**Vancouver Aquatic Centre – 1050 Beach Ave
DP-2025-00685 – R1-1**

Executive Summary

DEVELOPMENT PERMIT STAFF COMMITTEE RECOMMENDATION: APPROVE

Figure 6: Plan View CPTED conditions

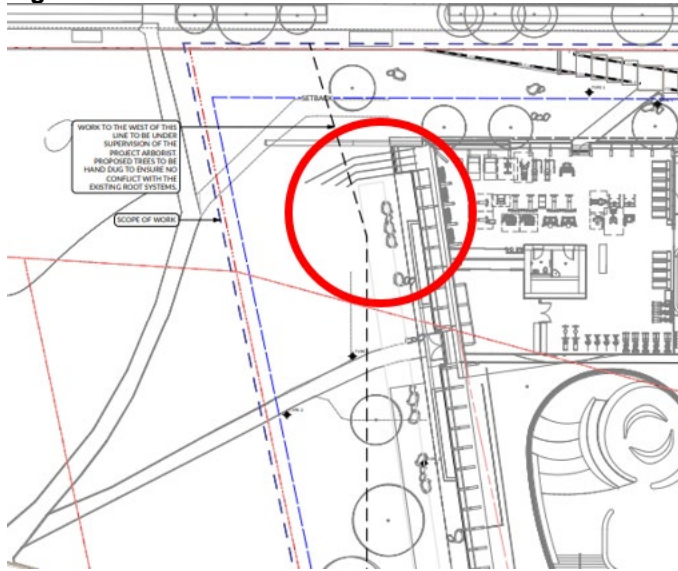
- A.1.7 design development to improve Crime Prevention Through Environment Design (CPTED) conditions at the northwest corner of the building.

Note to Applicant: Adding lighting or implementing other CPTED measures may improve perceptions of safety in this area. See *Figures 6 and 7* below.
